CITY OF ALBUQUERQUE

**RE: Church of the Risen Savior - Addition
Grading & Drainage Plan
Engineer's Stamp Date: 04/15/24
Hydrology File: D19D014**

**WAIVER APPLICATION FROM STORMWATER
QUALITY VOLUME MANAGEMENT ON-SITE**

GRADING & DRAINAGE PLAN

CG-101

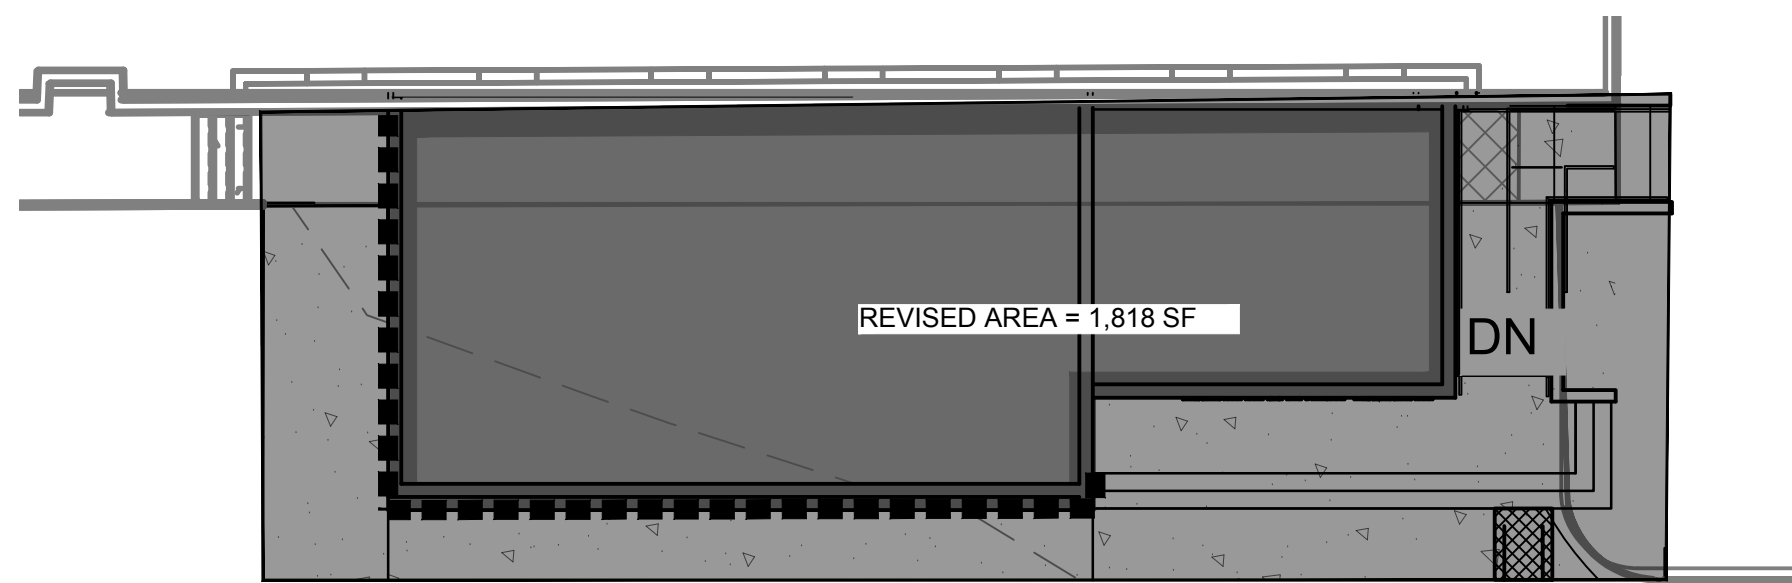
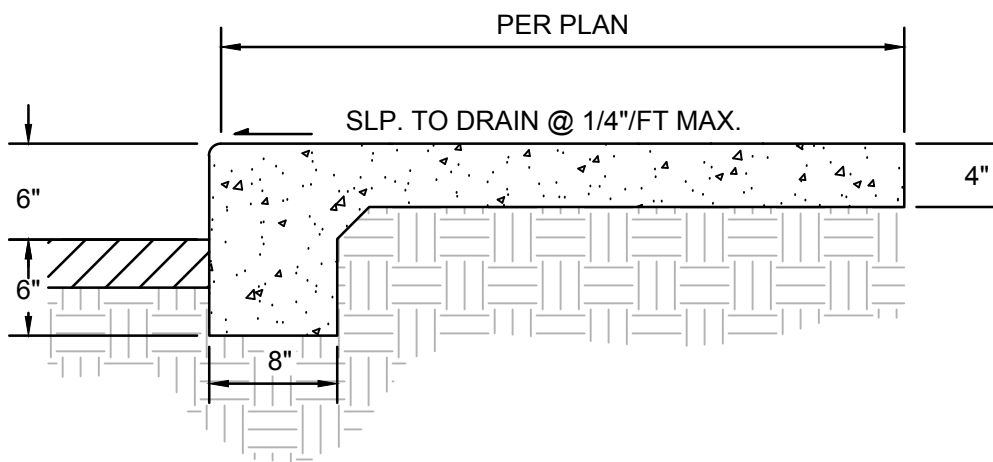
Based upon the information provided in your submittal received 04/15/2024, the Grading & Drainage Plan is approved for Building Permit and Grading Permit. Please attach a copy of this approved plan in the construction sets for Building Permit processing along with a copy of this letter.

1. Engineer's Certification, per the DPM Part 6-14 (F): *Engineer's Certification Checklist For Non-Subdivision* is required.
2. Please pay the Payment-in-Lieu of \$ **320.00** by emailing the attached approved Waiver Application from Stormwater Quality Volume Management On-site to PLNDRS@cabq.gov. Once this is received, a receipt will then be produced and email back. Follow the instructions on the bottom of the form and pay it at the Treasury in Plaza de Sol. Once paid, please provide me proof of payment.
